Reload Safety Evaluation Methods

NSPNAD-8608-A Revision 4

SUBJECT: MONTICELLO NUCLEAR GENERATING PLANT - REVIEW OF TOPICAL REPORT
NSPNAD-8608, REVISION 3, "RELOAD SAFETY EVALUATION METHODS FOR
APPLICATION TO THE MONTICELLO NUCLEAR GENERATING PLANT"
(TAC NO. M93388)

SAFETY EVALUATION BY THE OFFICE OF NUCLEAR REACTOR REGULATION
RELATING TO REVISION 3 OF TOPICAL REPORT NSPNAD-8608
RELOAD SAFETY EVALUATION METHODS FOR APPLICATION TO MONTICELLO
FOR
NORTHERN STATES POWER COMPANY
MONTICELLO NUCLEAR GENERATING PLANT
DOCKET NO. 50-263

Figure 3.2-107
Relative Power

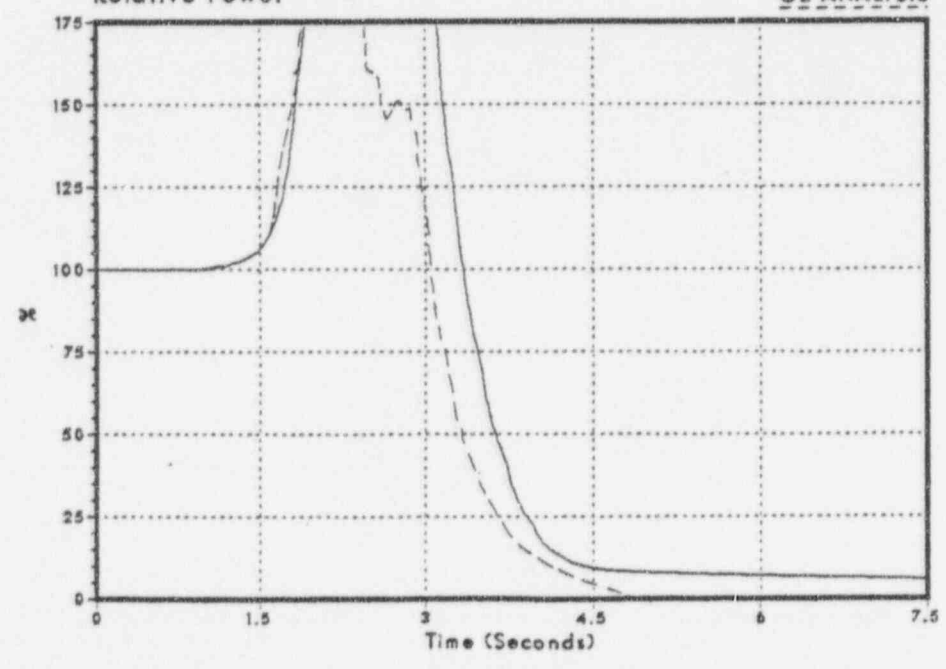
How do the DYNODE-B and ODYN peak powers in the load rejection, feedwater controller failure and MSIV closure transients of Figure 3.2-93, 3.2-100 and 3.2-107, respectively, compare? Are these differences due to DYNODE-B and ODYN modeling differences and, if so, why should they not be considered as a measure of the uncertainty in performing transient analyses of Monticello reloads?

The figures provided by the vendor which document the results of the ODYN analyses do not show values beyond those presented in Figures 3.2-93, -100, and -107. Thus, it is not possible to compare the peak powers between DYNODE-B and ODYN. Differences in peak power predictions are due to both modeling and input differences. Because of the extremely high slope of the power spike during these transients, the predicted peak value is highly sensitive to any changes which affect the time at which the peak occurs; thus, meaninglessly small input changes can produce large changes in peak power.
